## **D.L. ATCHISON SUBDIVISION**

APPLICATION NUMBER 3 DATE September 3, 2009

REQUEST Subdivision

# DETAIL SITE PLAN

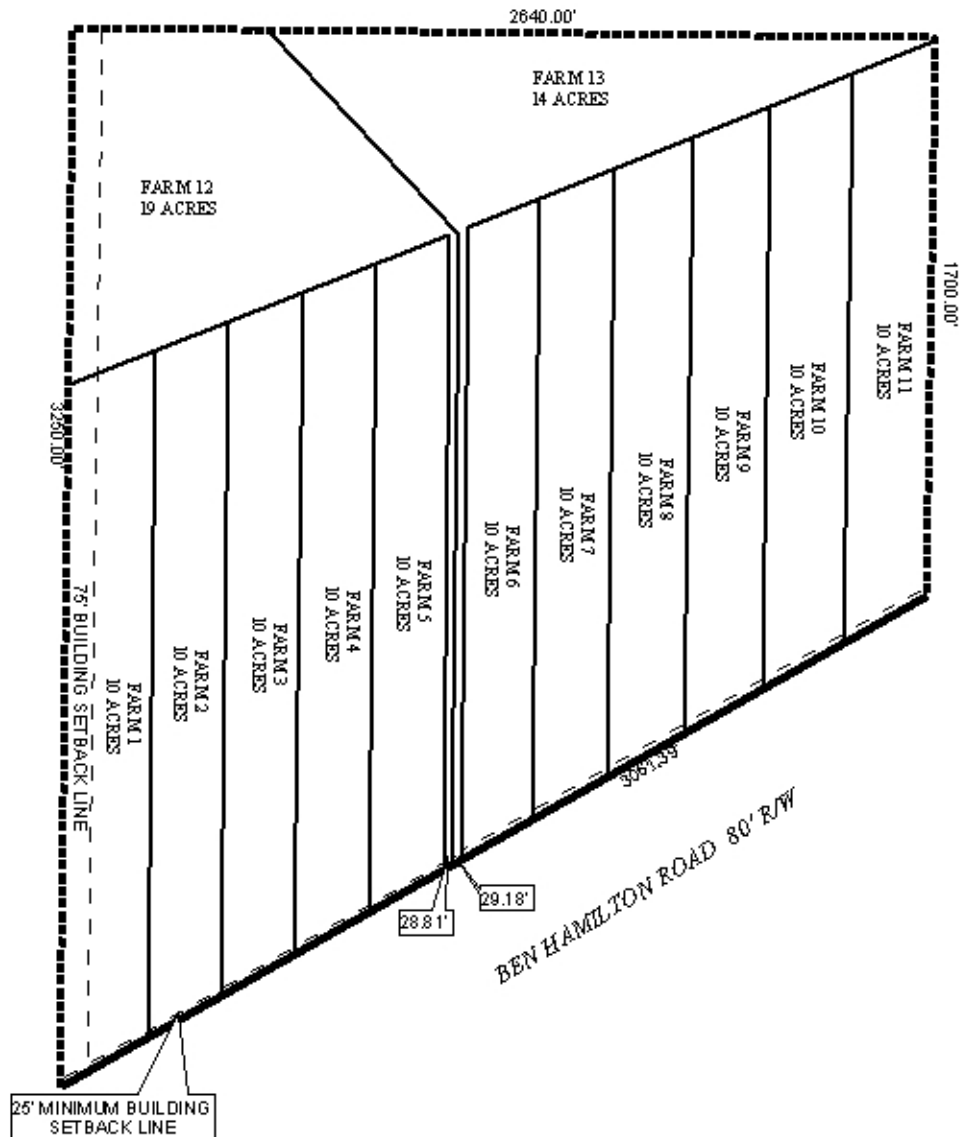
As proposed, Lots 1-10 have 260' – 300' of frontage along Ben Hamilton, while Lots 11 and 12 are flag lots with 25' of frontage each. If approved, a note should be placed on the final plat stating that each lot is limited to one curb cut to Ben Hamilton Road, with the size, location, and design to be approved by County Engineering and in conformance with AASHTO standards.

As mentioned, Lots 11 and 12 are flag lots. Section V.D.1 of the Subdivision Regulations states that “panhandle or flag lots shall generally not be allowed, but may be permitted only in those locations where varied and irregularly-shaped designs are common and the informality of design is consistent with other lots in the vicinity; or, where unusual circumstances such as an odd shaped lot exists; or, separate disparate uses exist on a single lot; or, where there are natural or pre-existing man-made barriers which may cause an undue hardship on the land owner; or in the case of a family division.” None of the aforementioned scenarios pertain to this application. In any event, the “poles” are over 1900' in length, hardly characteristic of any flag lot approved by the Commission in the past. Furthermore, there are no existing lots in the vicinity that would justify proposed Lots 1-10, which exceed the maximum depth allowance of Section V.D.3 of the Subdivision Regulations. The maximum depth of lots shall be 3.5 times the width; the applicant is proposing lots with ratios over 7.5.

However, if approved, the applicant should illustrate a 25' minimum building setback line on all lots (along Ben Hamilton Road); on Lots 11 and 12, the setback line shall be from where the “poles” meets the “flag” portions of the lots. Also, if approved, a note should be placed on the final plat stating that no future subdivisions of Lots 11 and 12 will be allowed until additional frontage on a public street is provided.

The plat meets the minimum size requirement for developments with access to public water and individual septic tanks. However, if approved, it is requested that the applicant revise the preliminary plat to label the lots with their sizes in square feet, or provide a table on the plat with the same information.

- 1) the plat does not comply with Section V.D.1 or V.D.3 of the Subdivision Regulations.

- 1) reducing the number of proposed lots to a maximum of 8 lots;*
- 2) increasing the amount of frontage for flag lots to 60' (each) to allow for the construction of a public street; and*
- 3) reducing the depth of any non-flag lots to comply with Section V.D.3 of the Subdivision Regulations.*
